SELF EVALUATION NEEDS ASSESSMENT AND TRANSITION PLAN

PREPARED FOR
Holliday Development

Timberlake Apartments
Inman, SC
Site Visit on April 20, 2026

Photo 013

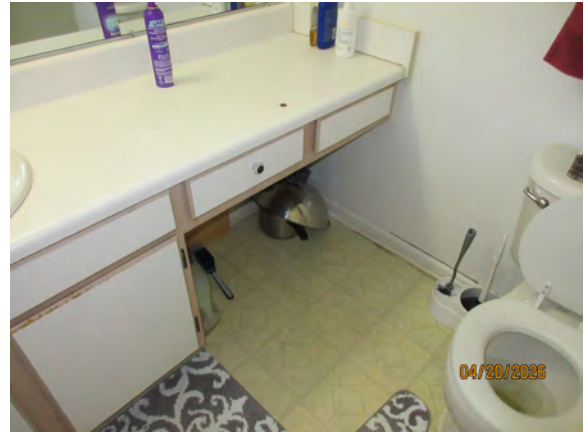
7. Remodel bathroom lavatory to provide required toe and knee clearances. (Unit 905(2BR): See photos 013, 014 and 019.; Unit 907(2BR): See photo 045, 046 and 051; Unit 1412(3BR): See photo 081.; Unit 1410(3BR): See photo 101)

Photo 023

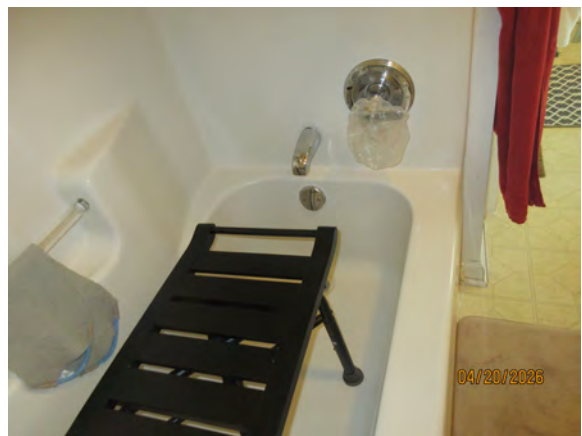
10. Replace bathroom in-tub seat(s) with in-tub seat(s) that meet all requirements. (Unit 905(2BR): See photo 023)

Photo 067

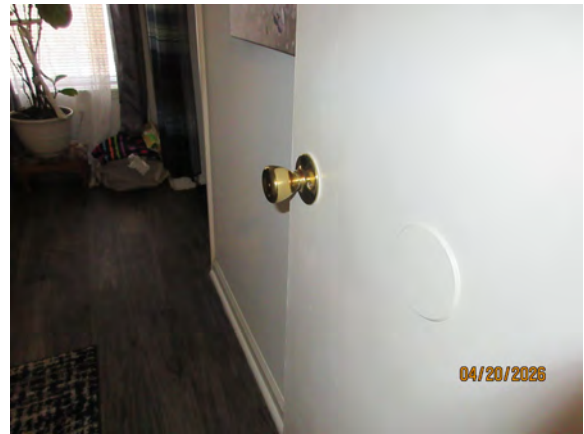
21. Replace refrigerator with one that meets all requirements. (Unit 905(2BR): See photo 037.; Unit 907(2BR): See photo 067; Unit 1412(3BR): See photo 094.; Unit 1410(3BR): See photo 115)

Photo 076

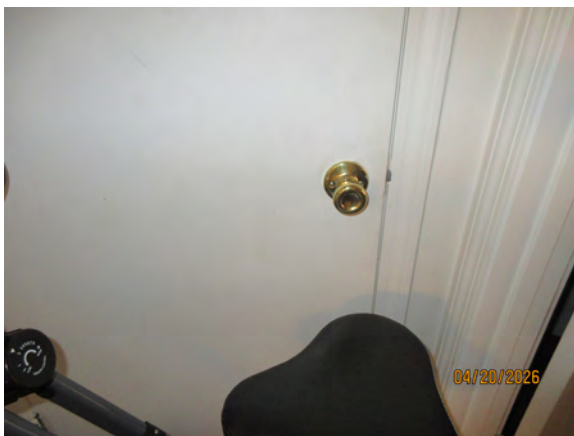
3. Replace dwelling unit storage door hardware with regulation type. (Unit 905(2BR): See photo 008.; Unit 907(2BR): See photo 043.; Unit 1412(3BR): See photo 076.; Unit 1410(3BR): See photo 099 for laundry unit door.)

Photo 079

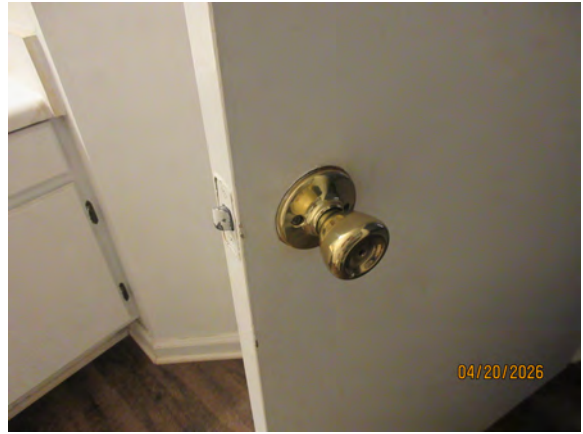
1. Remodel laundry to provide required turn around clear space. (Unit 905(2BR): See photo 026.; Unit 907(2BR): See photo 059; Unit 1412(3BR): See photos 078 and 079 - Laundry hook ups are in a tiny side closet.; Unit 1410(3BR): See photo 099 and 100.)

Photo 259

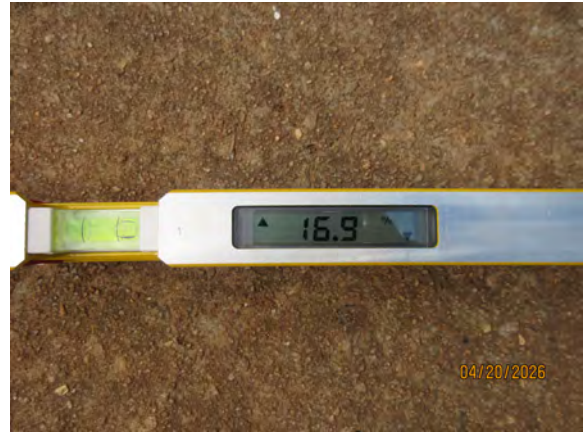
Replace or install accessible parking signs that meet all regulations. (Sign is missing. See photo 285)	\$55	2nd year by Apr 2028
Accessible Route Pathways :	Remodel accessible pathway to be within regulation slope. (See photos 259 and 260)	\$492	2nd year by Apr 2028
	Remodel accessible pathway to be within regulation cross slope. (See photos 223 and 224.; See photos 255 -256, 261-262)	\$1,414	2nd year by Apr 2028
Accessible Route Curb Ramps :	Remodel curb ramp(s) along the accessible route to be within required slope. (See photo 279 and 280; See photo 290 and 291)	\$2,128	3rd year by Apr 2029
